# D49 TRANSPORTATION CENTER

FALCON, CO

Pending. Project # U-22-001.  
Scheduled for planning Commission  
6/16/22. Planner: Ryan Howser

# Site Development Plan\_V1.pdf Markup Summary

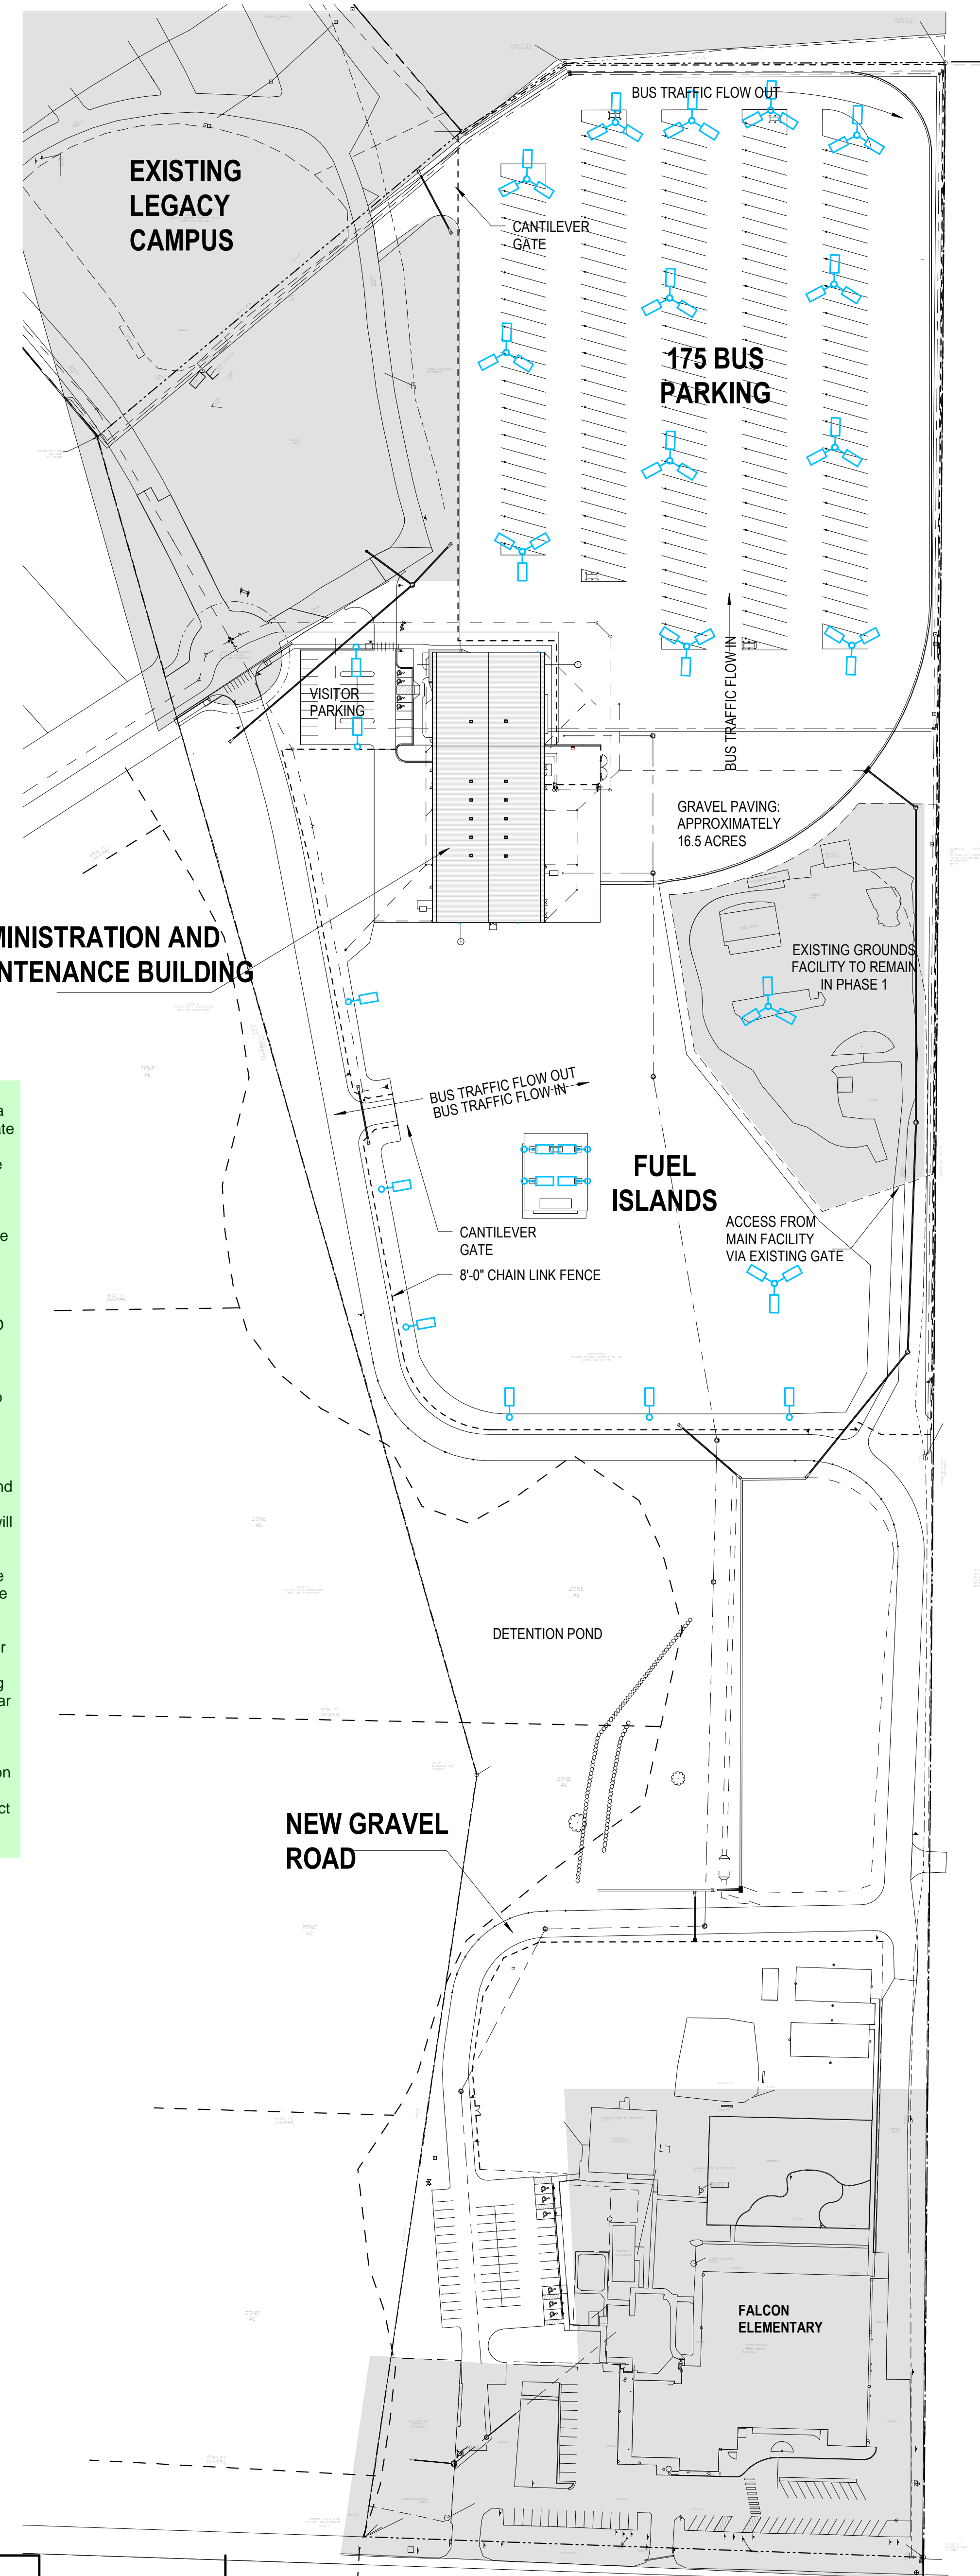
Please remove this block

Add detailed scope of work, with break down of phases.

Include in Project Data: calculation for parking for office and maintenance building  
provide standard parking stalls, ADA, loading, bike racks, etc.  
Parking computations - required/ provided

Open space, landscaping, and impermeable surface percentage

Provide phone # and email for both

Cite existing land use type (e.g., educational, etc.)

Per the Land Development Code, any parking areas greater than 25 parking spaces shall be a paved parking lot. Construction drawings indicate gravel parking lot - please revise or submit an alternative parking plan to be considered by the PCD Director. Please see Sec. 6.2.5.D.1.a.vi:

- Review Criteria: To approve an alternative parking plan, the PCD Director shall find that the proposed alternative plan accomplishes the purposes of this Section equally well or better than a parking plan which complies with the standards of this Section. In reviewing the request for an alternative parking plan, the PCD Director shall take into account the number of employees, the number of expected customers or clients, the availability of shared parking (if any), or any other factors that may be unique to the applicant's request. The applicant has the burden of proof. Generally, a TIS containing a trip generation analysis, parking analysis study or by other relevant data describing the transportation impacts and clearly identifying and discussing the modifications and alternatives proposed and the ways in which the proposal will better accomplish the purpose of this Section than would a parking plan which complies with the standards of this Section should support the request. The PCD Director shall not approve the alternative parking plan unless it: (1) Does not detract from continuity, connectivity and convenient proximity for pedestrians between or among existing or future uses in the vicinity; (2) Minimizes the visual and aesthetic impact along the public road by placing parking lots to the rear or along the side of buildings, to the maximum extent feasible; (3) Minimizes the visual and aesthetic impact on the surrounding neighborhood; (4) Creates no physical impact on any facilities serving alternative modes of transportation; (5) Creates no detrimental impact on natural areas or features; and (6) Maintains handicap parking ratios.

Fix text alignment for all contacts

Provide plan preparer name, and contact information

SHEET NO.  
DP-01

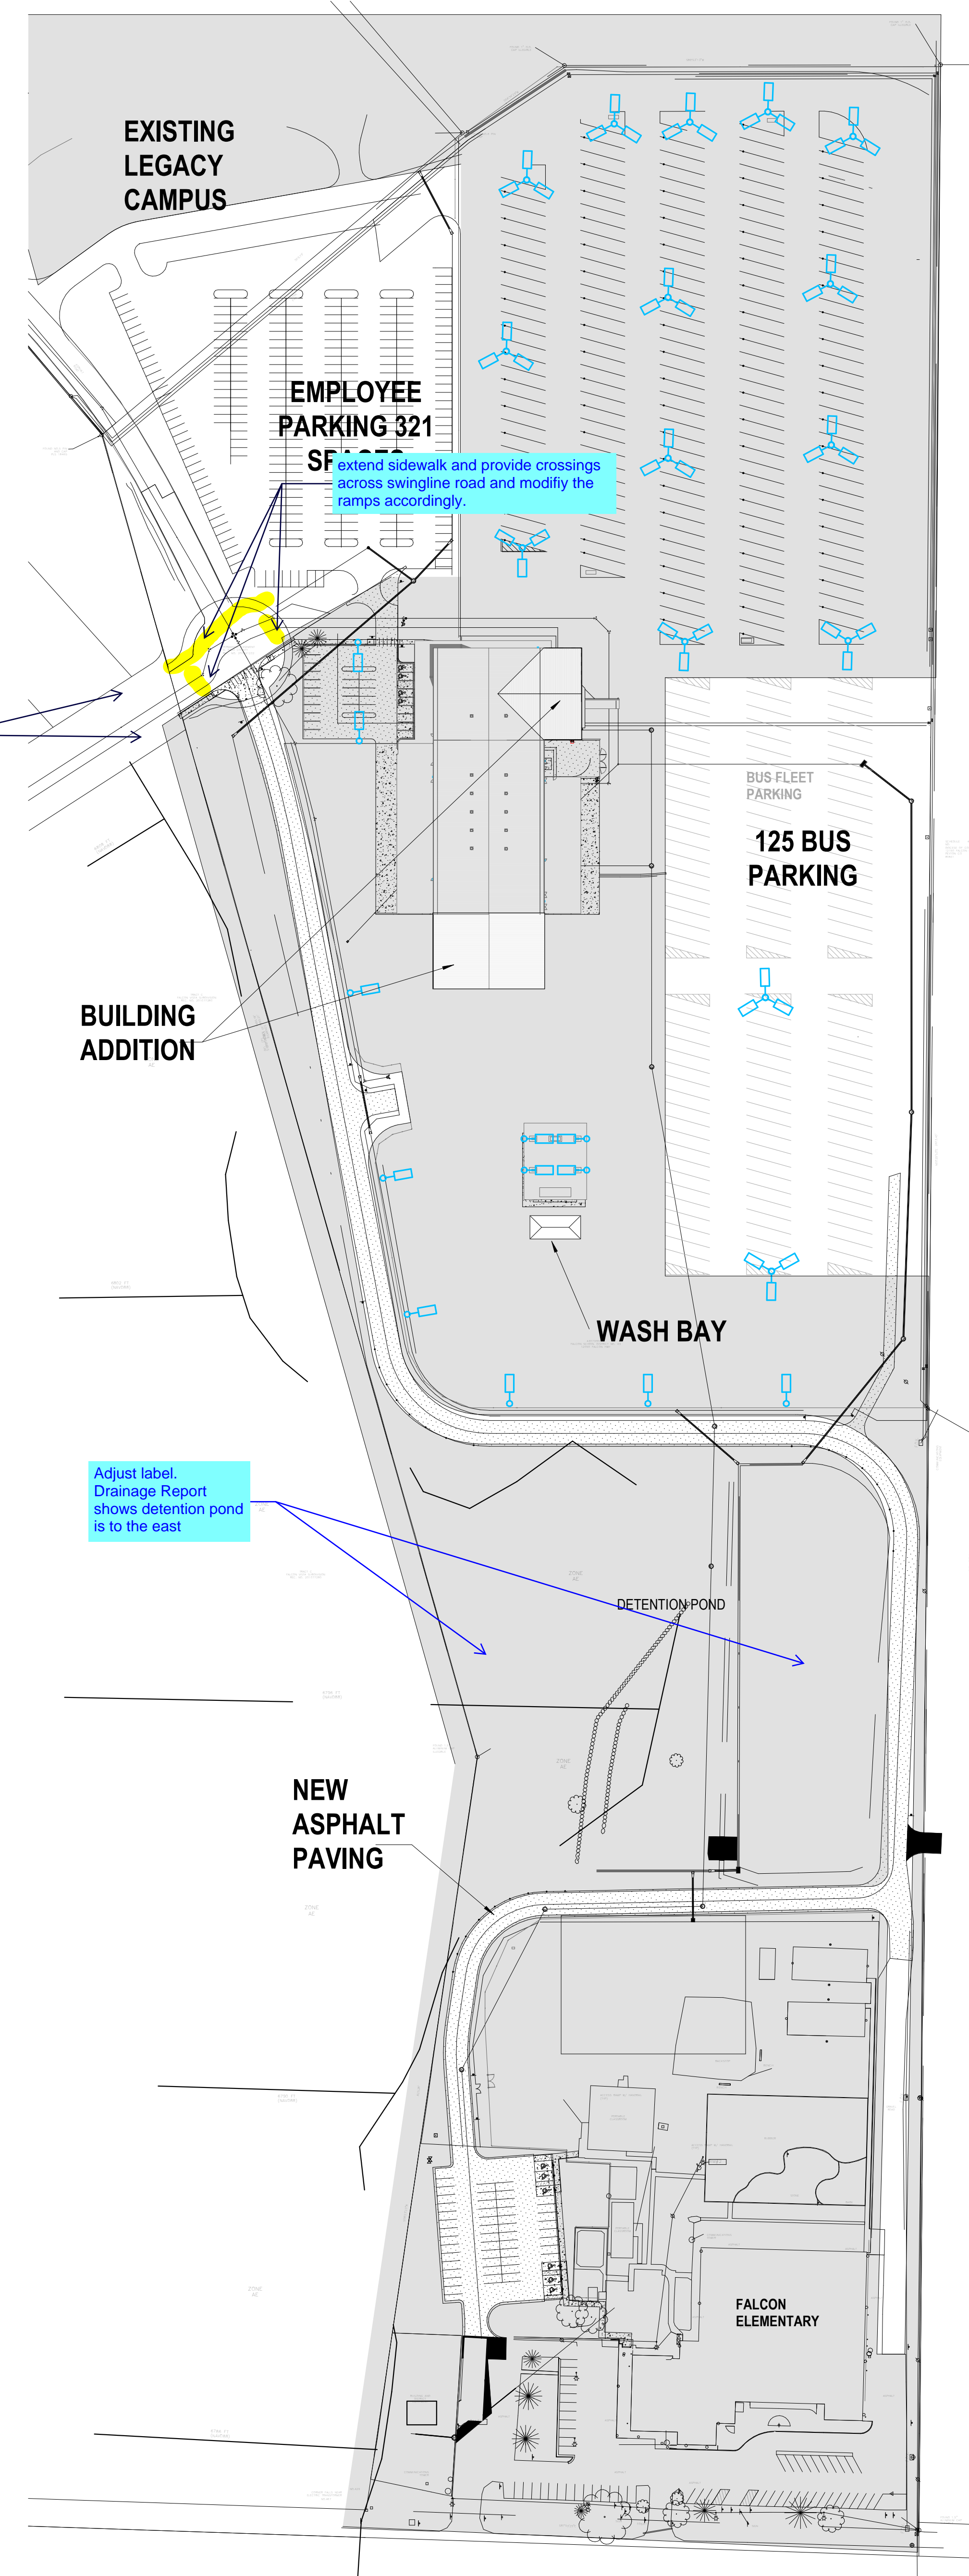
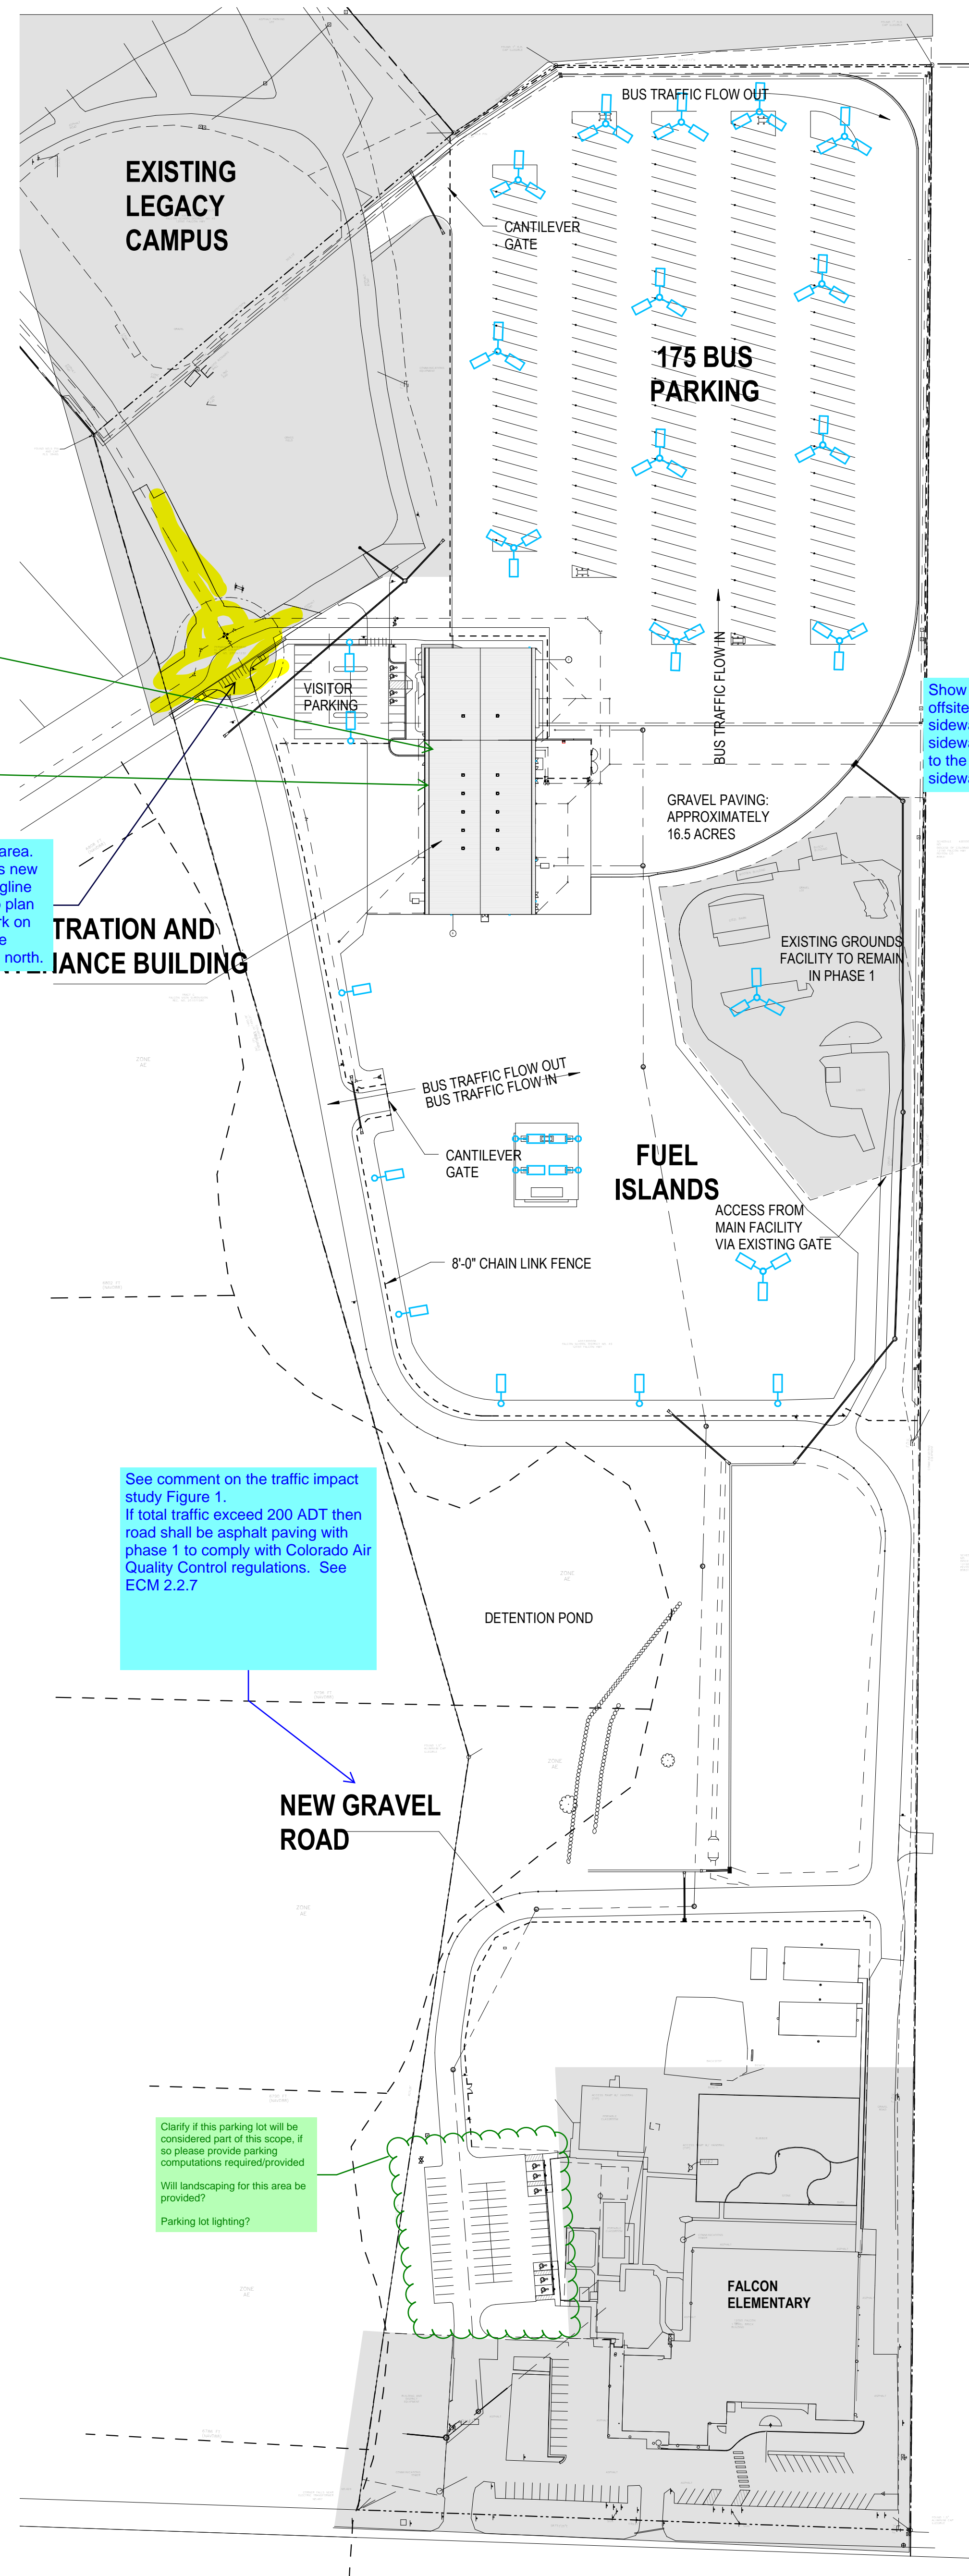
Provide sf - office / maintenance building

Show setback distances from all existing and proposed buildings to property lines

Adjust shaded area. The south leg is new access to Swingline Rd. The Demo plan also shows work on the bulb and the driveway to the north.

Show the existing offsite C&G and sidewalk. Proposed sidewalk to connect to the existing sidewalk

Extend sidewalk and provide crossings across swingline road and modify the ramps accordingly.

Adjust label. Drainage Report shows detention pond is to the east

See comment on the traffic impact study Figure 1. If total traffic exceed 200 ADT then road shall be asphalt paving with phase 1 to comply with Colorado Air Quality Control regulations. See ECM 2.2.7

Clarify if this parking lot will be considered part of this scope. If so please provide parking computations required/provided. Will landscaping for this area be provided? Parking lot lighting?

Include the following on the plan:

- Location of all sidewalks, fences, walls, retaining walls, or berms
- Location of all ADA ramps, signs, and ADA pathways
- Location of all no-build areas, floodplain, drainageways and facilities

- Location and dimensions of all existing and proposed signage on site
- Location of all garbage receptacles with graphical depiction of screening mechanism

- Location of all existing and proposed utility lines and associated infrastructure
- Location of existing and proposed water and wastewater infrastructure, including well and septic locations, if applicable

- Show locations and dimensions of all property lines, setbacks, rights-of-way and existing and proposed easements.
- Traffic circulation on site including all points of ingress and egress into the property

- The layout and location of all off-street parking, loading and other vehicular use areas, unless otherwise depicted in detail on a separate parking plan. If depicted on a separate parking plan then depiction of the parking areas are required

Please refer to SDP Checklist
